Access Compliance Report Public Rights-of-Way (Curb Ramps)

Intersection ID: N/AMain Street:BACK_CREEK_DRCross Street:W_T_HARRIS_BVLocation:SWADA ID: DFAA336B65C3Ramp Type:PerpInitial Pass/Fail:FailOverall Compliance:NoSeverity Score:12.5

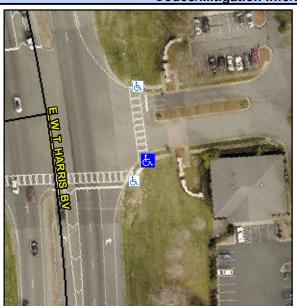
Possible Solutions:	<u>Co</u>
Remove & Replace Entire Ramp.	N/A
	Yes
	N/A
	N/A
	N/A
	N/A
Surveyor Notes:	N/A
N/A	N/A
	N/A
	N/A
	N/A
PROW/ADA:	N/A
Not Found, R304.2.2	N/A
	N/A
	N/A
	N/A

Field Measurements/Component Compliance							
Comp	liance Description	Data	Comp	liance Description	Data		
N/A	Ramp Length (in)	96.0	No	Ramp Slope (%)	8.9		
Yes	Ramp Width (in)	48.0	Yes	Ramp XSlope (%)	0.6		
N/A	Flare Type LT	N/A	N/A	Flare Type RT	N/A		
N/A	Flare Slope LT (%)	N/A	N/A	Flare Slope RT (%)	N/A		
N/A	Flare Traversable LT?	N/A	N/A	Flare Traversable RT?	N/A		
N/A	Landing Length (in)	N/A	N/A	DWS Provided?	N/A		
N/A	Landing Width (in)	N/A	N/A	DWS Contrast?	N/A		
N/A	Landing Slope (%)	N/A	N/A	DWS Length (in)	N/A		
N/A	Landing X Slope (%)	N/A	N/A	DWS Full Width?	N/A		
N/A	Landing Curb? (Y/N)	N/A	N/A	DWS Offset (in)	N/A		
N/A	Shared Landing?	N/A					
N/A	Gutter Ponding?	N/A	N/A	Gutter Slope (%)	N/A		
N/A	Gutter Lip Ht (in)	N/A	N/A	Gutter X Slope (%)	N/A		
N/A	Painted X Walk1?	Yes	N/A	Painted X Walk2?	N/A		
	X Walk 1 Direction	To N		X Walk 2 Direction	N/A		
N/A	X Walk 1 Width (in)	111.0	N/A	X Walk 2 Width (in)	N/A
